MONITORING YEAR 2 ANNUAL REPORT Final

OWL'S DEN MITIGATION SITE

Lincoln County, NC
DEQ Contract 005150
DMS Project Number 95808

RE: Owl's Den Mitigation Site-Year 2 Monitoring Report
Final Submittal for DMS
Contract Number 004673, RFP Number 16-004110, DMS# 95360
Yadkin River Basin – CU# 03040105; Union County, NC

Figure 3.1 Integrated Current Condition Plan View (Sheet 1 of 3)
 Owl's Den Mitigation Site
 DMS Project No. 95808
 Monitoring Year 2 - 2017
 Lincoln County, NC

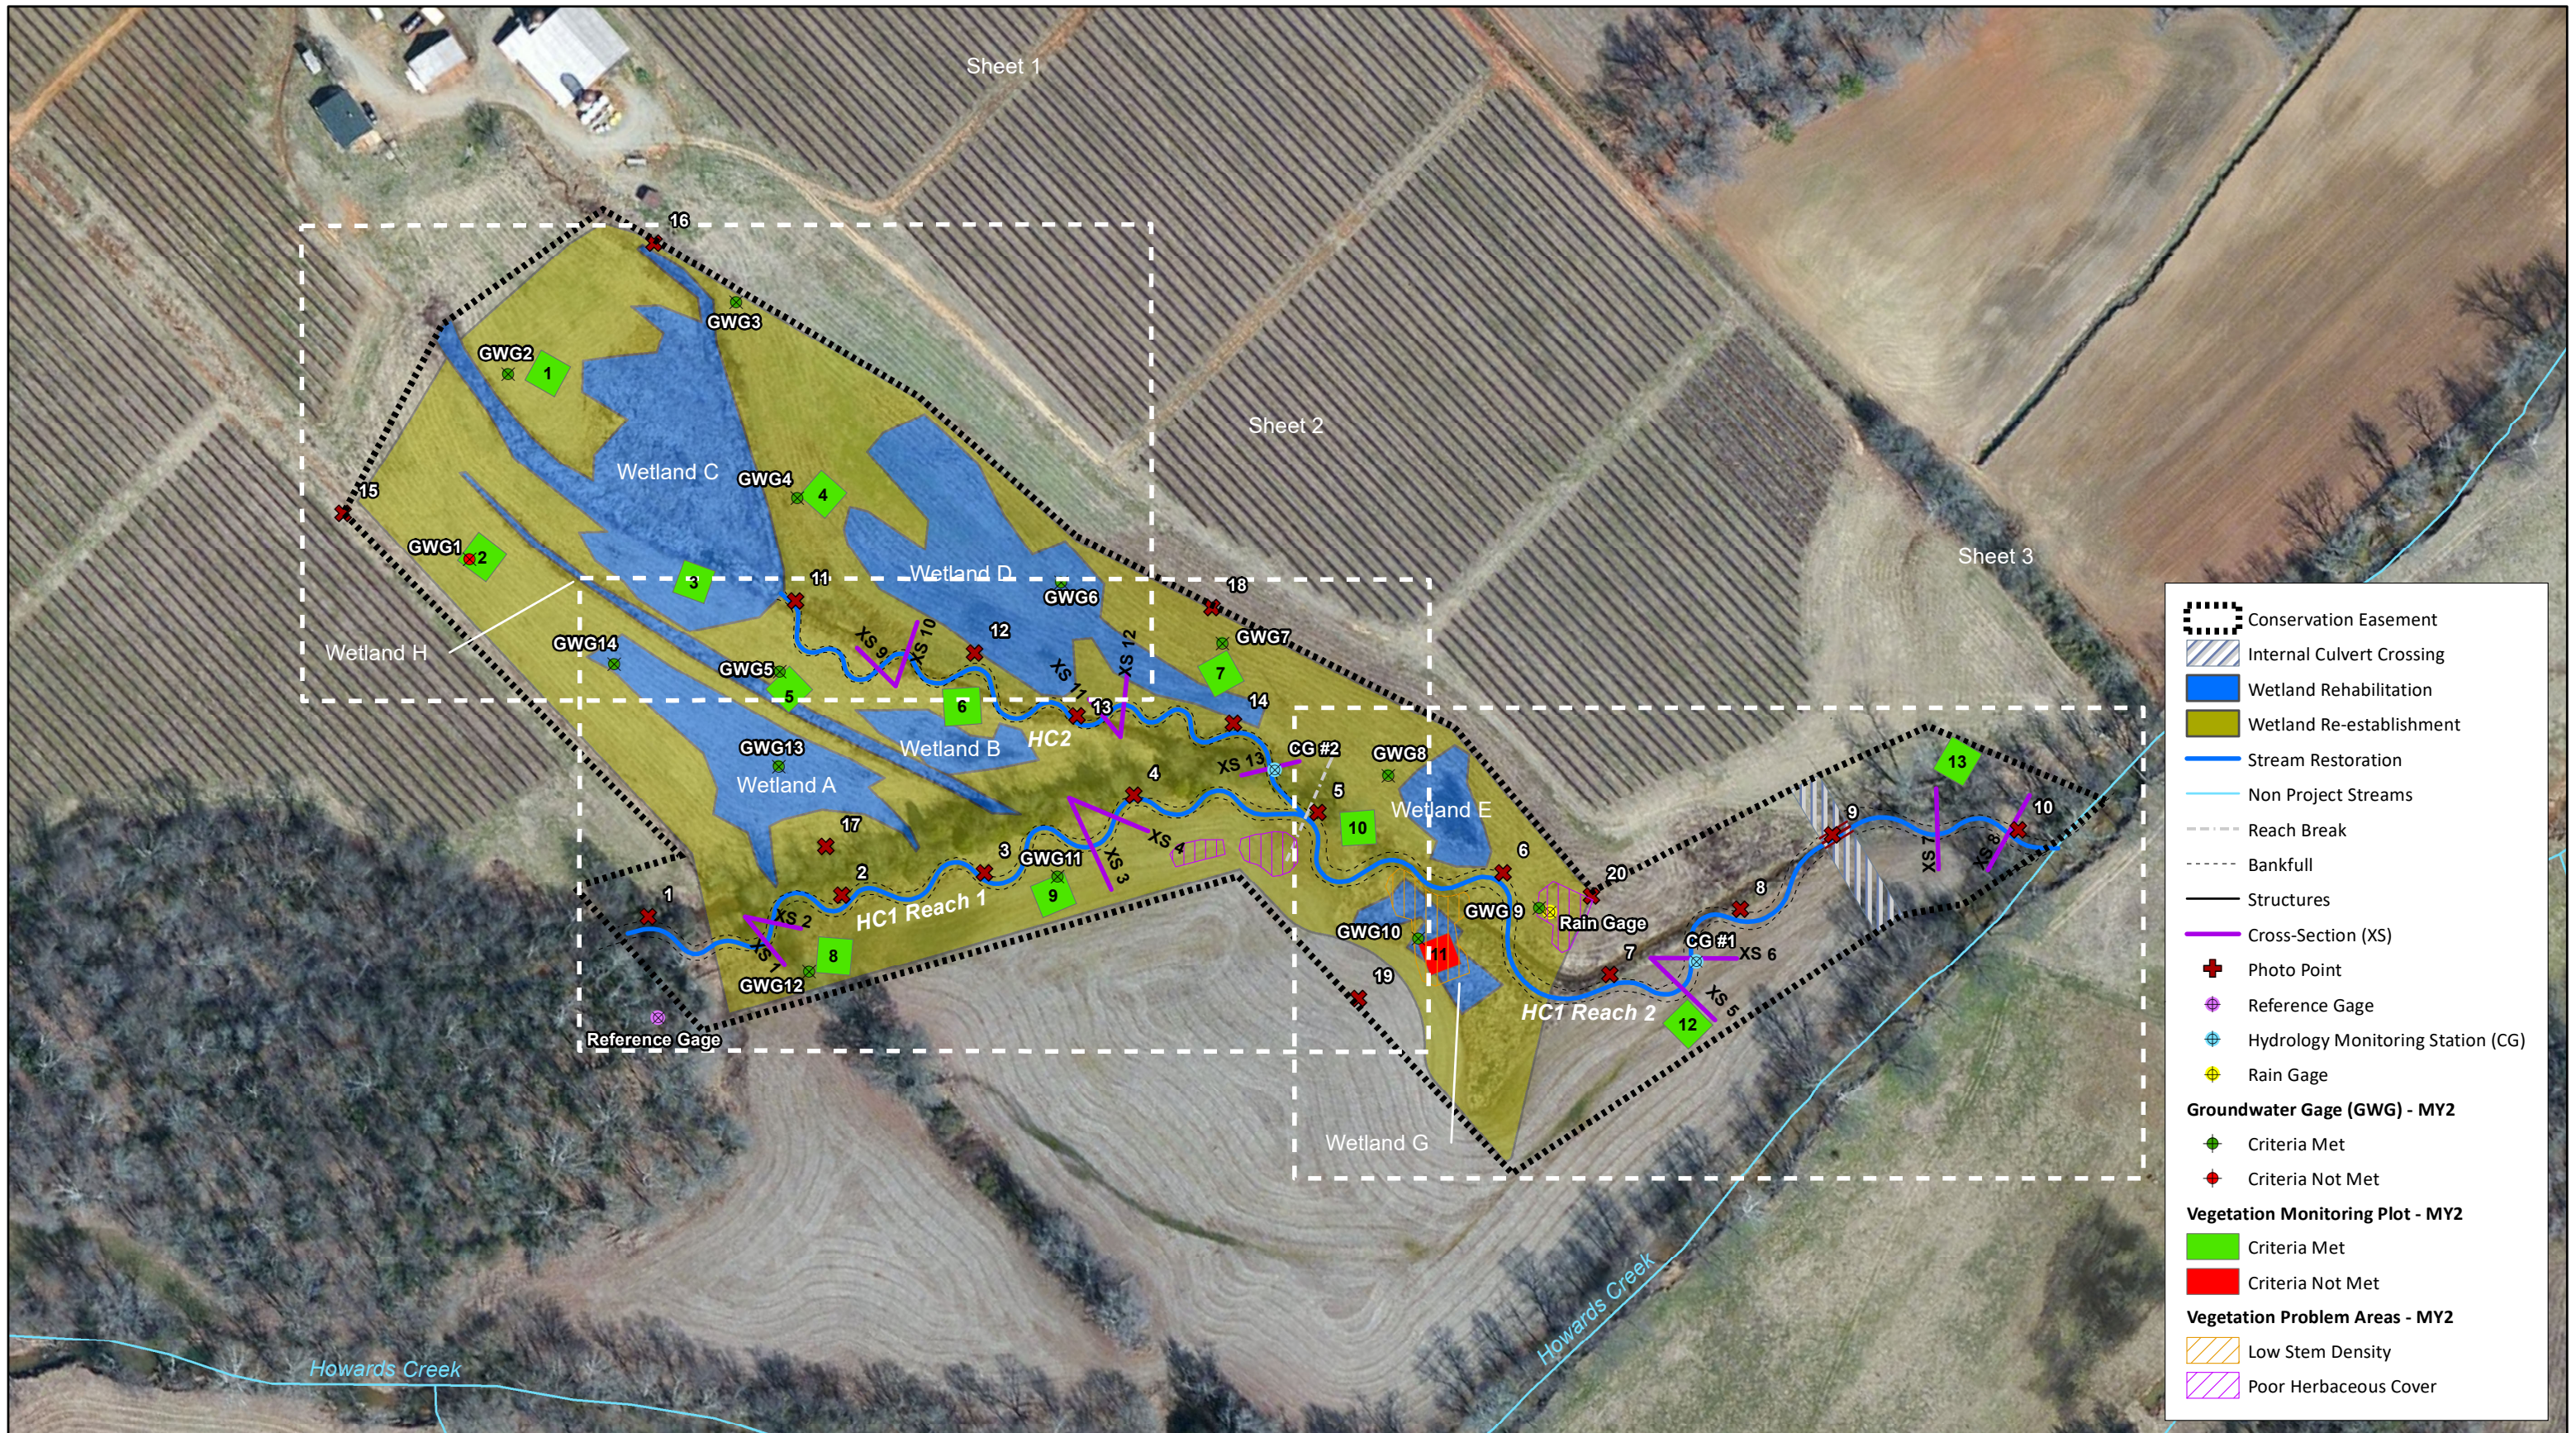
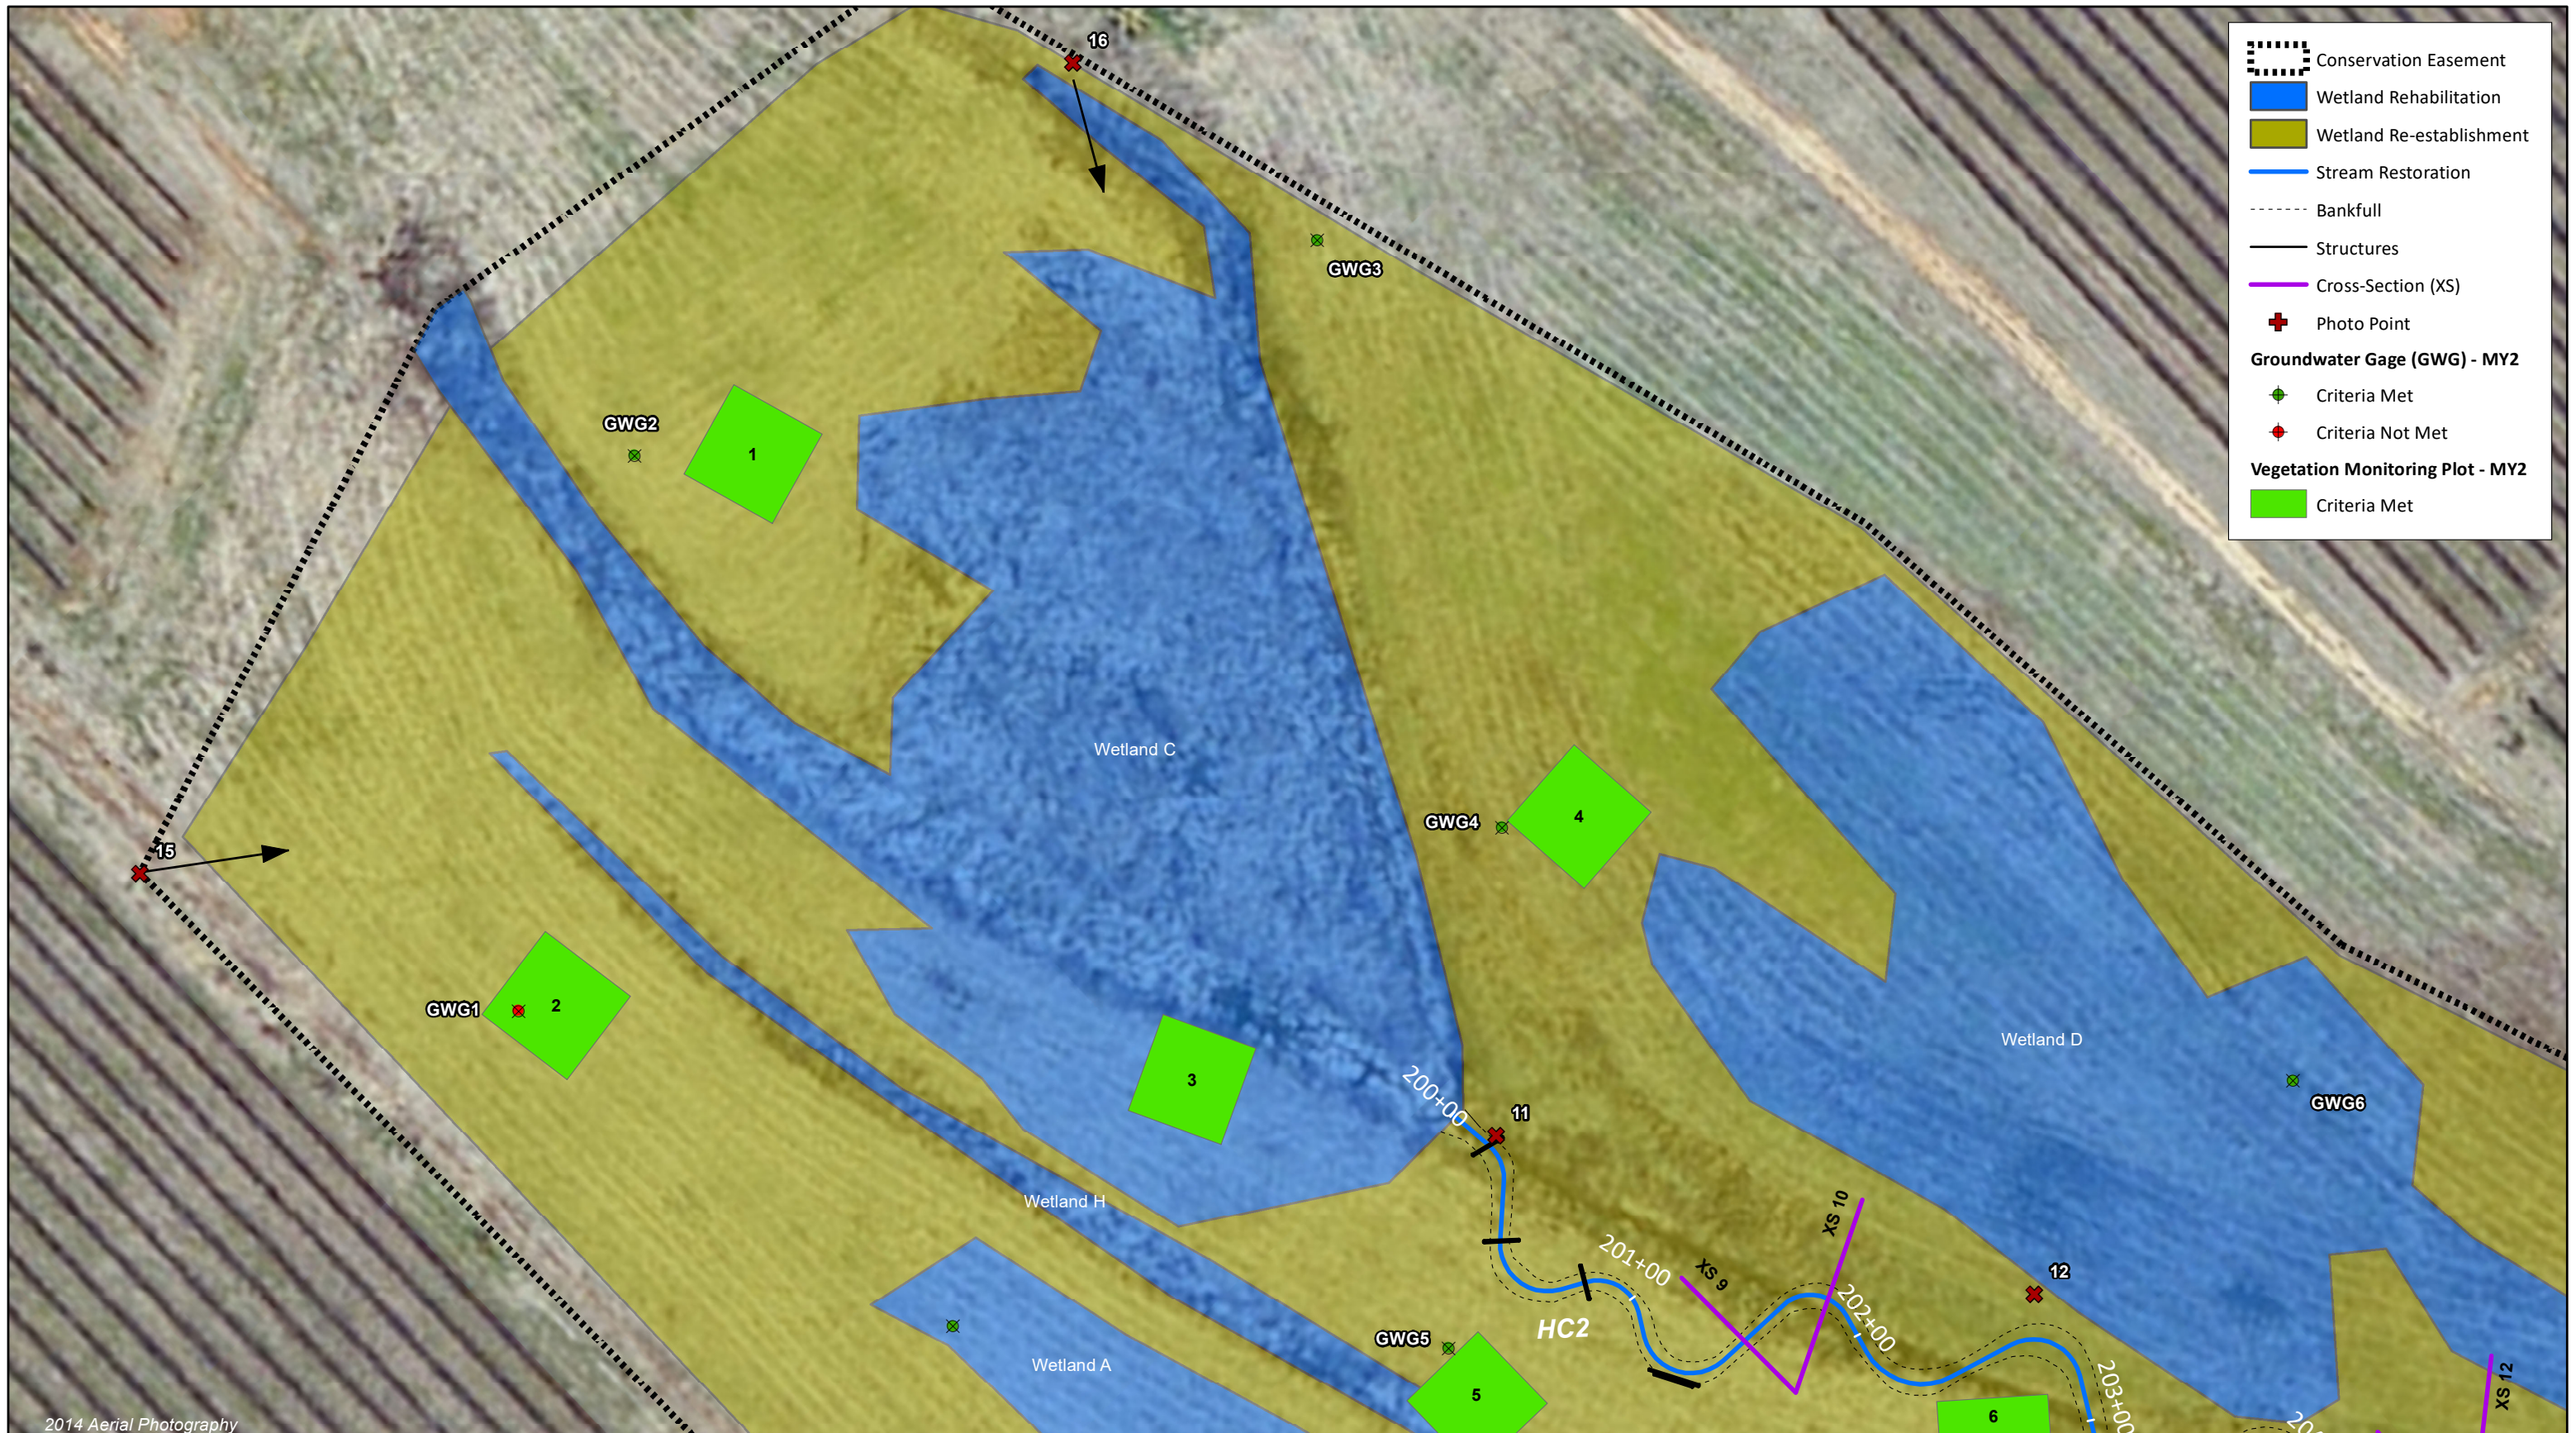
This section reports an area near VP3 with low planted woody stem density. The CCPV mapping does not show any low stem density areas near VP3. The low stem density areas are shown near VP 11. Please update the report and/or CCPV maps accordingly.

Wildlands Response; The report verbiage in Section 1.2.5 has been updated to note the area near VP11 has low planted woody stem density rather than VP3. No changes were made to the CCPV map.
